Addendum #3

Invitation to Tender 2021-11

Daycare project at School ÉEC Sainte-Croix, Tiny

Architectural Addendum No. 1

E4.0-A-1

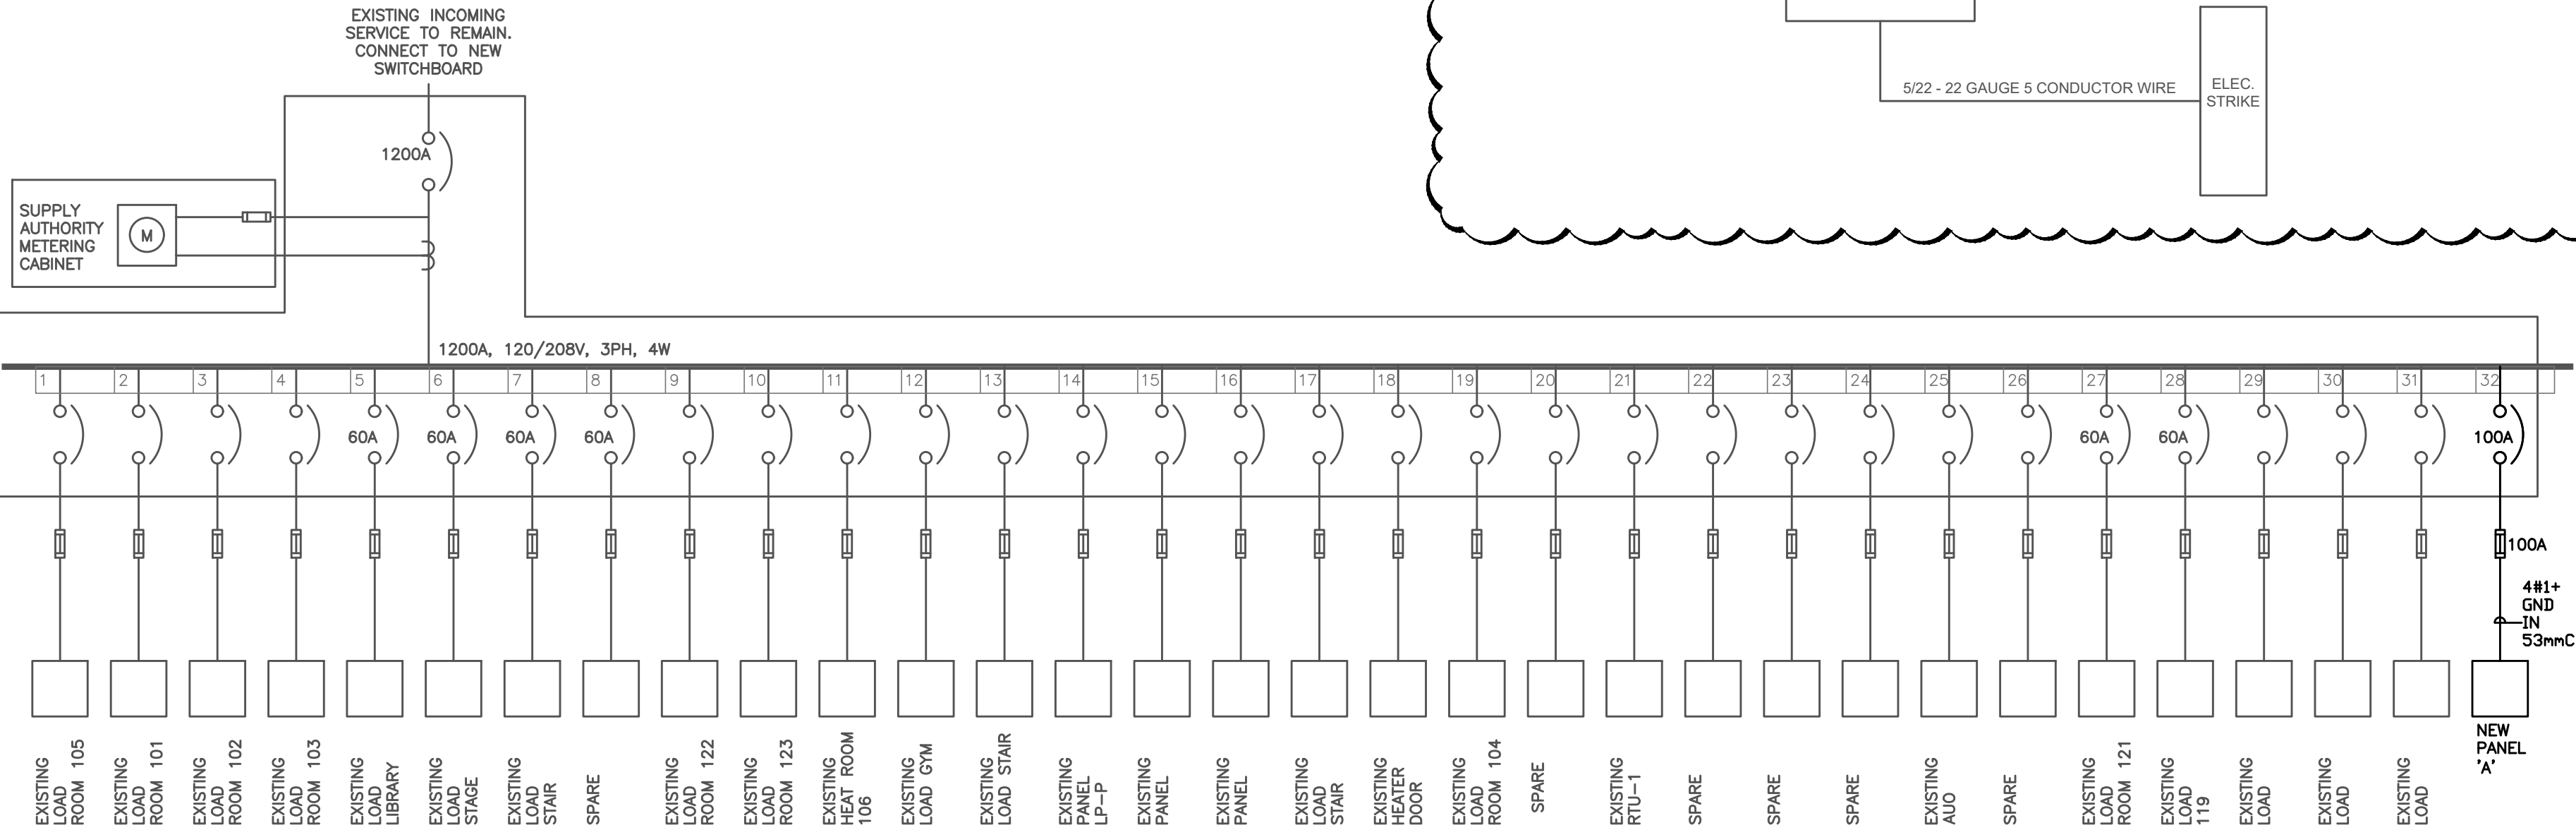
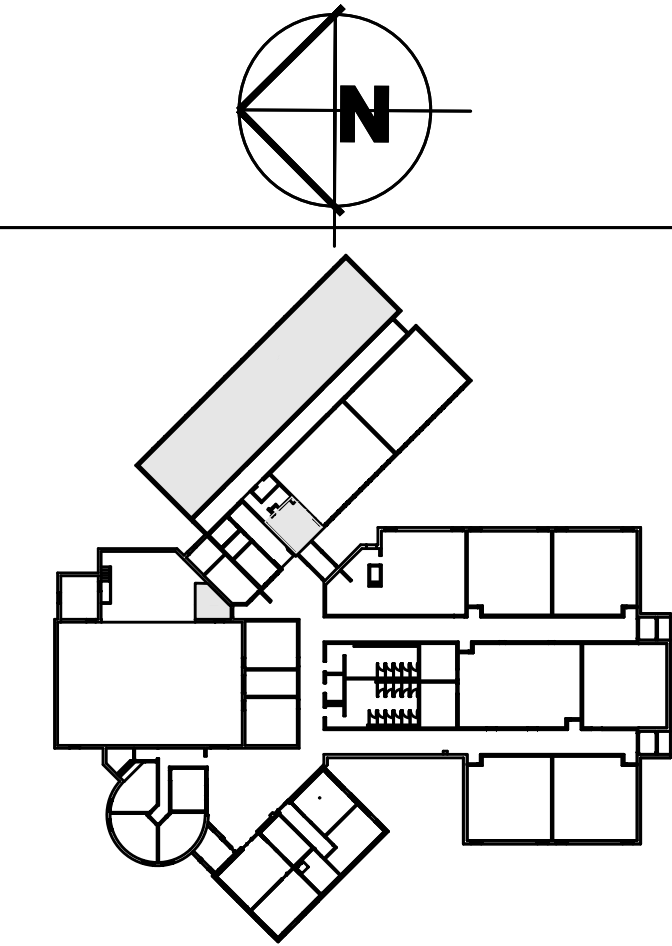
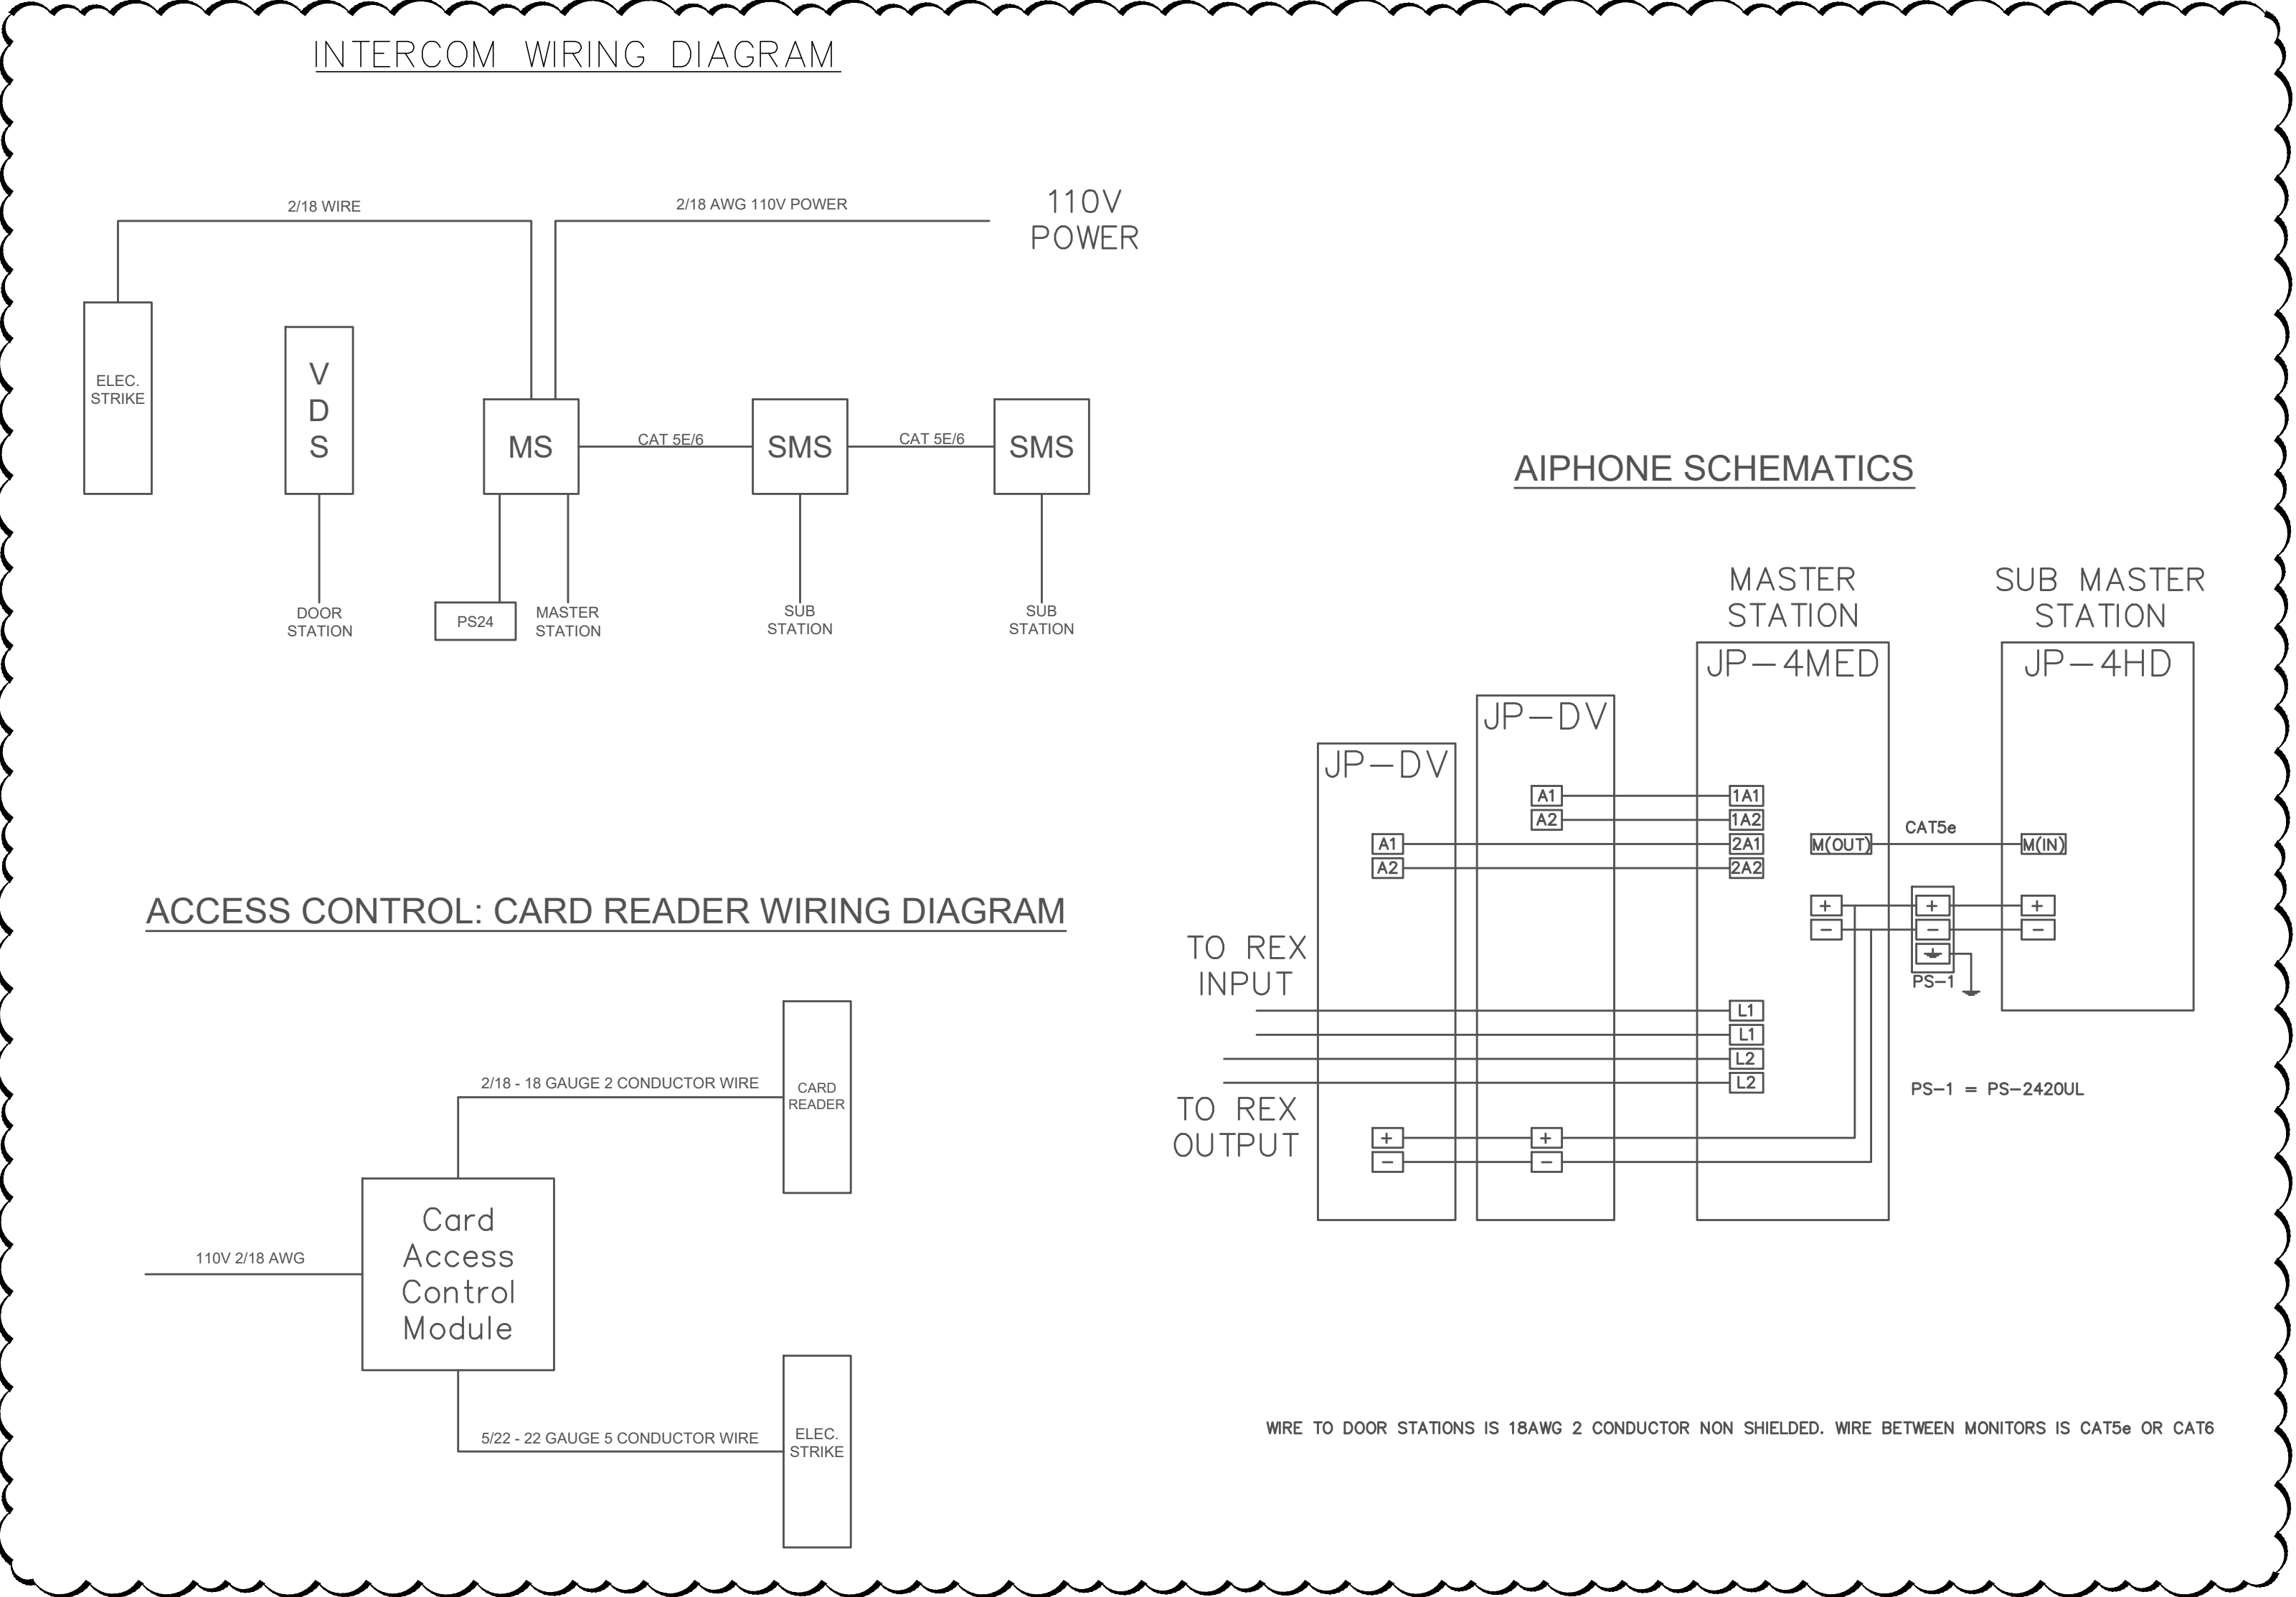
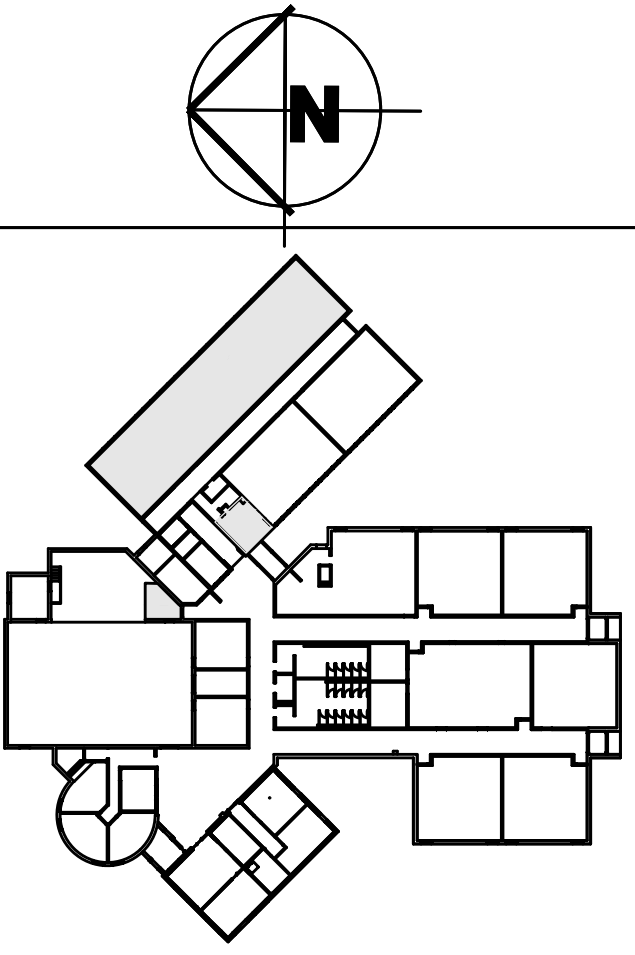
1. Refer to attached electrical sketch E3.0-A-1, changes are shown as clouded in the attached electrical sketch.
2. Refer to attached electrical sketch E4.0-A-1, Changes are shown as clouded in the attached electrical sketch.
3. Refer to additional electrical drawings E6.0, Intercom specifications added.
4. All fire alarm work related to this project shall be done by the base building fire alarm contractor through cash allowance, electrical contractor shall as part of the contract provide and install 21mm conduit for all the fire alarm device shown on the electrical drawings.
5. All Security card access work and integration with the intercom shall be done by the base building Security card access contractor through cash allowance, electrical contractor as part of contract shall provide and install 21mm conduit for all the security devices shown on the electrical drawings.
